**Device**            **TC27x**  
**Marking/Step**   **ES-DC, DC**  
**Package**           **see Data Sheet**

## 10216AERRA

This Errata Sheet describes the deviations from the current user documentation.

**Figure 1 Message buffer transfer from Message RAM to OBF**

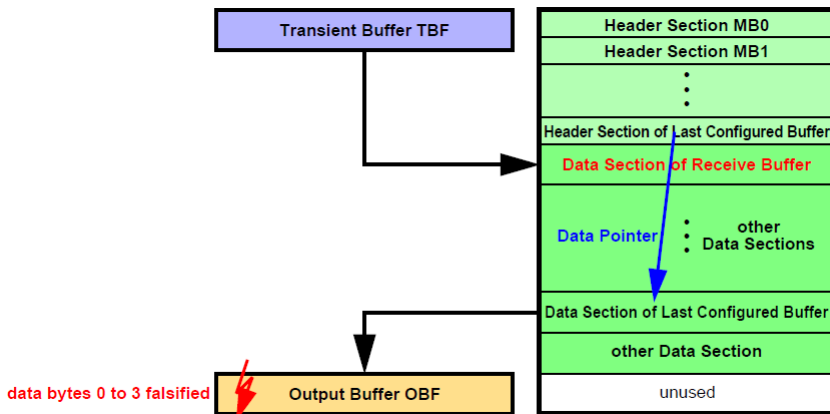
When the message buffer has its payload configured to maximum length (**PLC = 127**), the OBF word on address 00h (payload data bytes 0 to 3) is overwritten with unexpected data at the end of the transfer.

a) When a message is transferred from the Last Configured Buffer in the Message RAM to the OBF and **PLC** = 127 it may happen, that at the end of the transfer the OBF word on address 00h (payload data bytes 0 to 3) is overwritten with unexpected data (see [Figure 1](#)).

**Figure 2 Message buffer transfer from IBF to Message RAM**

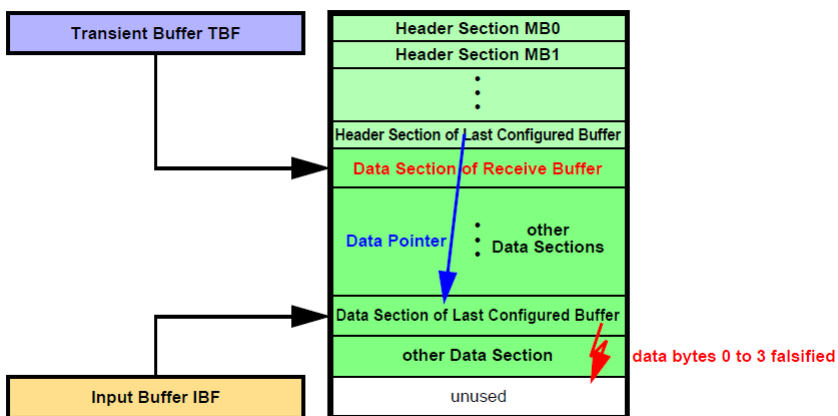
After the Data Section of the selected message buffer in the Message RAM has been written, one additional write access overwrites the following word in the Message RAM which might be the first word of the next Data Section.

b) When a message is transferred from IBF to the Last Configured Buffer in the Message RAM, it may happen, that at the end of the transfer of the Data Section one additional write access overwrites the following word, which may be the first word of another message's Data Section in the Message RAM (see [Figure 2](#)).

Figure 3 Message RAM Configurations

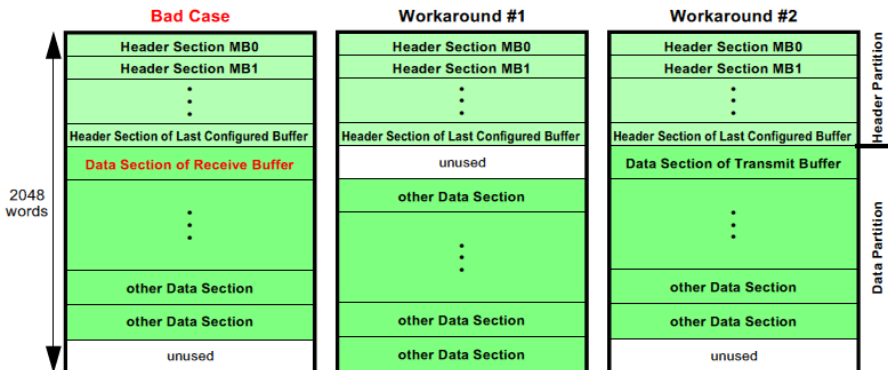
The erratum is limited to the case when (see [Figure 3](#) “Bad Case”):

2) Ensure that the Data Section directly following the Header Partition is assigned to a transmit buffer.

**Figure 4 Example sequence showing how registers ETRRx may be filled with “Error Free” addresses**

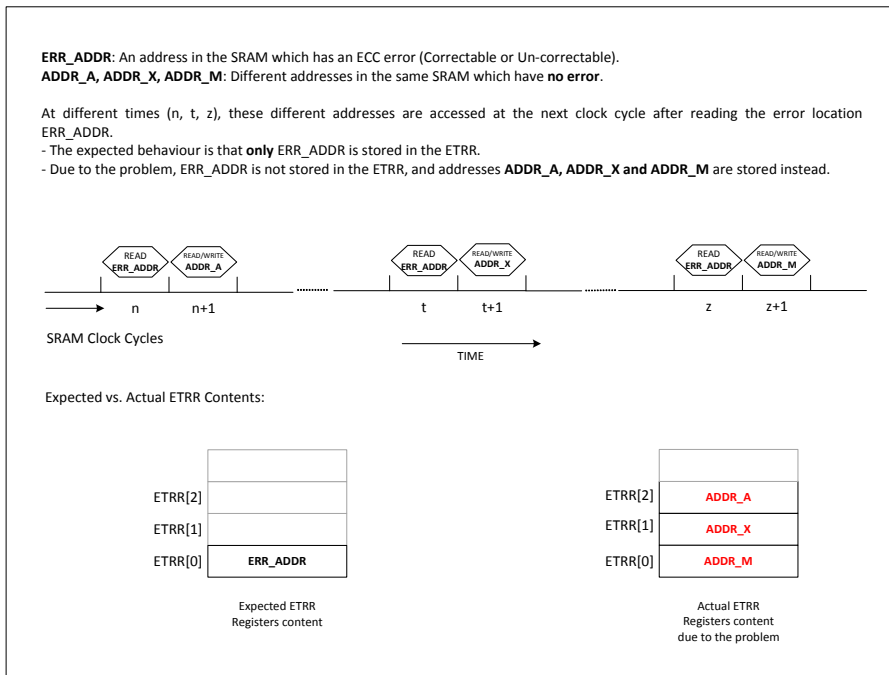
When such a consecutive access sequence (read from ERR\_ADDR followed by read/write of different address(es)) happens multiple times, registers ETRRx are filled with addresses that have actually no error – and the SRAM address which actually has an error is not stored indeed. **Figure 4** shows such an example scenario.

The consequence of the scenario explained in **Figure 4** is that a single error in the SRAM – example just one correctable error at a location ERR\_ADDR – can result in registers ETRRx getting filled with fault-free address, and thus potentially even triggering an ETRR overflow.

**Figure 5 Recommended Software Handling - Flowchart**

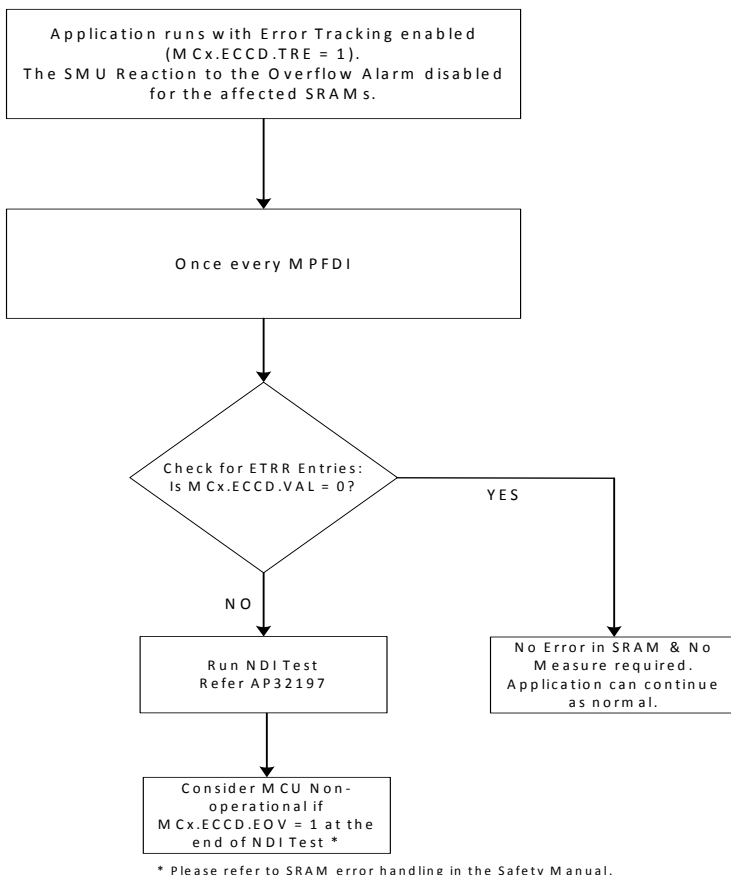
A flowchart of the recommended software handling is shown in [Figure 5](#).

If there is at least one valid ETRR entry (i.e.  $MCx.ECCD.VAL \neq 0$ ) then the software shall run a Non-Destructive-Inversion (NDI) Test on the affected SRAM. Please refer to application note AP32197 (AURIX™ Memory tests using the MTU) for an example regarding running this test.

At the end of this test, if an ETRR overflow is detected ( $MCx.ECCD.EOV = 1_B$ ) then the MCU shall be considered non-operational. Refer to section on Correctable SRAM Error handling in the Safety Manual.

**Figure 14 Ripple Voltage vs. Frequency Characteristic**

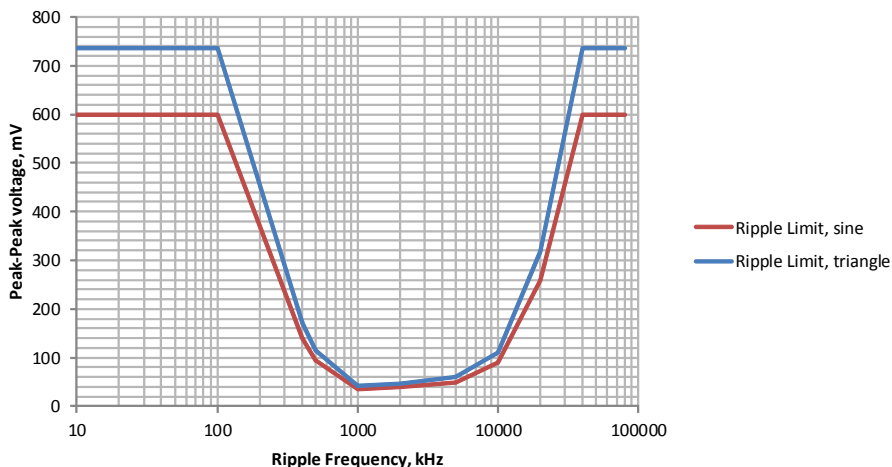
The internal back-up clock is sensitive to specific power supply voltage disturbance/ripple caused by a voltage ripple intrinsic to DC-DC converters. Specific conditions such as insufficient filtering of the ripple may lead to improper behavior of the start-up scheme of the back-up clock, and thus stuck-at state during the start-up of the microcontroller until this condition is removed.

The diagram reflects acceptable ripple level during the cold start of the microcontroller at the respective VDDP3/VEXT/VEVRSB supply of the PMS subsystem, depending on the device and package type, as shown in the following table.

**Figure 16 SENT Tolerance of this Design Step**

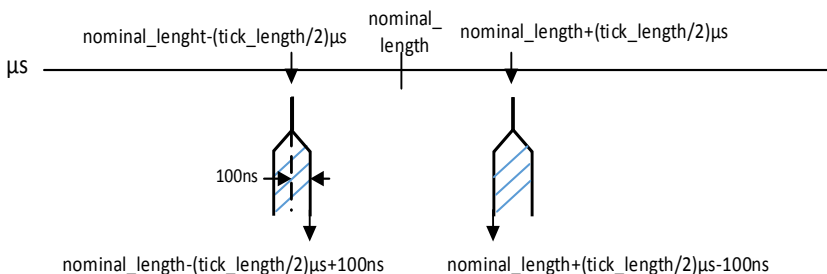
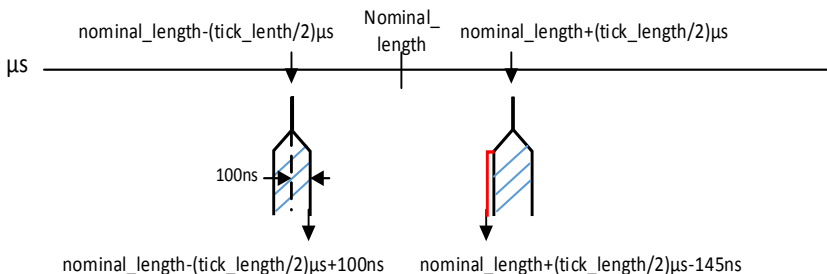
- The lower border is  $\text{nominal\_value} - (\text{tick\_length}/2) \mu\text{s} + 100 \text{ ns}$
- The upper border is  $\text{nominal\_value} + (\text{tick\_length}/2) \mu\text{s} - 100 \text{ ns}$ .

- The lower border is  $\text{nominal\_value} - (\text{tick\_length}/2) \mu\text{s} + 100 \text{ ns}$
- The upper border is  $\text{nominal\_value} + (\text{tick\_length}/2) \mu\text{s} - 145 \text{ ns}$ .

**Figure 17 Short Serial Message, Serial Data Encoding over 16 messages**

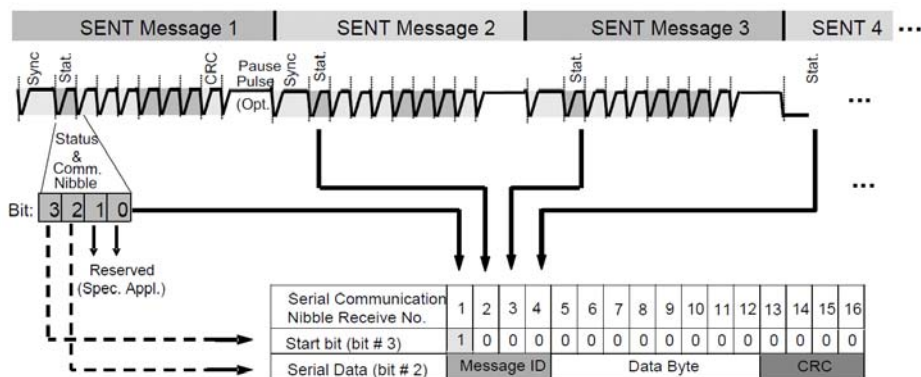
In Figure “Short Serial Message, Serial Data Encoding over 16 messages” of the SENT chapter, the arrows originating from bits 2 and 3 of the Status & Comm Nibble are routed incorrectly and must be swapped.

**Figure 17** shows a corrected version of this figure.
